Submission S001 (John Lowrie, California Department of Conservation, Division of Land Resource Protection, November 3, 2011)

Subject: Notice of Potential Public Acquisition of Williamson Act Lands for the Fresno to Bakersfield Section of the California High-Speed Train (HST) Project, Fresno, Kings, Tulare and Kern Counties

Response to Submission S001 (John Lowrie, California Department of Conservation, Division of Land Resource Protection, November 3, 2011)

Figure 1: Severed Farmland Acreage Example, Sheet 42

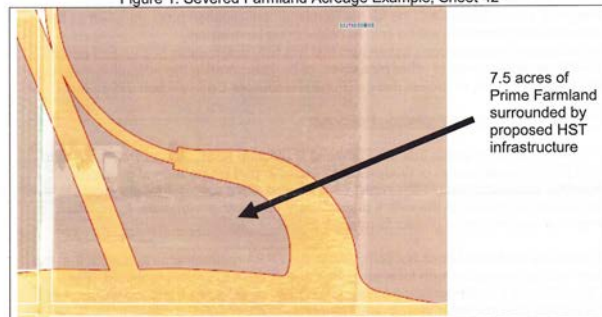
For example, the severed farmland acreage on Sheet 42 (Identification number 002160004000), per the DEIR, does not qualify for mitigation as specified by the direct effect or permanent impact classification although it is bounded on all sides by HSR proposed infrastructure. Refer to Figure 1 below:

It is highly advisable that the severed acreage in these parcels be given direct-effect-permanent impact status because this acreage cannot be consolidated with neighboring farmland and/or cannot be accessed safely for agriculture production purposes. Table 1 includes examples of acreage that should be added to the values outlined in Mitigation Measure Ag-MM #1.

The Authority has revised AG-MM #2 for the Revised DEIR/Supplemental DEIS to a

project design feature. With this revision a more robust description on the Farmland Consolidation Program was provided. The Program will "assist landowners in obtaining lot line adjustments where appropriate to incorporate remnant parcels into a larger parcel that is consistent with size requirements under the local government general plan." This will make it so the HST project will comply with the Farmland Protection Policy Act requirements to ensure, to the extent practical, comply with local policies to protect farmland, by using lot-line adjustments to solve minimum parcel size provisions.
